FINAL DECISION AND RESPONSE TO COMMENTS

NIPSCO Bailly Generating Station, Area C
246 Bailly Station Road
Chesterton, Indiana
EPA ID: IND 000 718 114

EPA RESPONSE TO COMMENTS

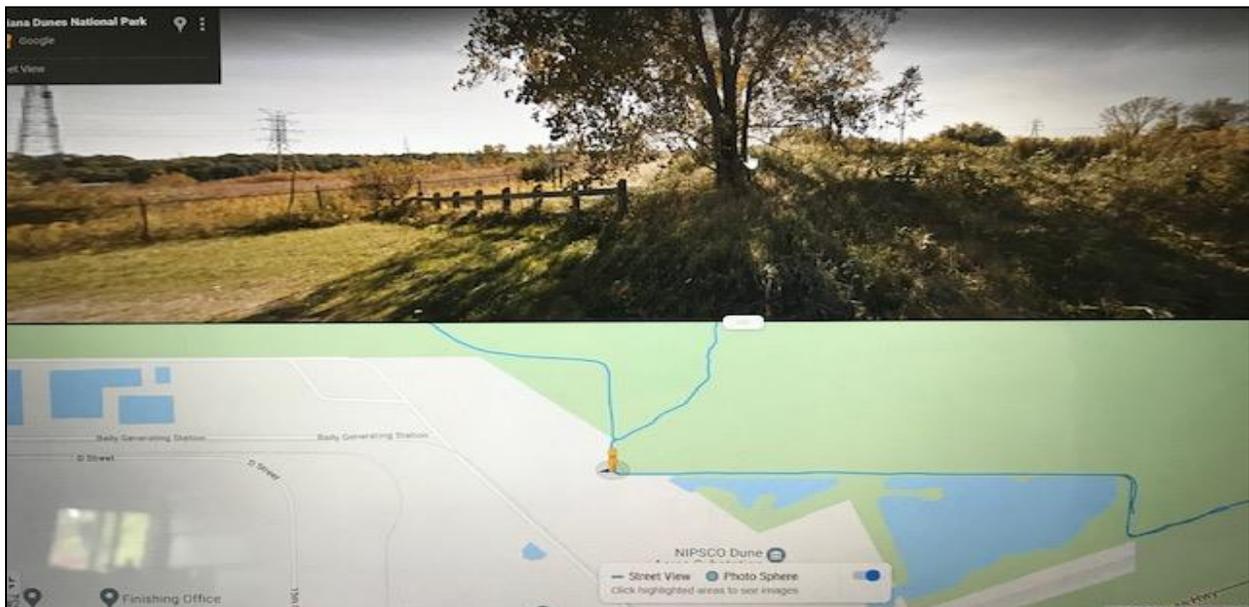
The degree of environmental damage that has occurred due to the placement of coal ash in SWMU 15 is presented in Sections III, IV and Attachment C of the SB. The footprint of the contamination is limited to an area adjacent to the Facility and shown in the SB Figure 10. Below is a summary from the SB for convenience.
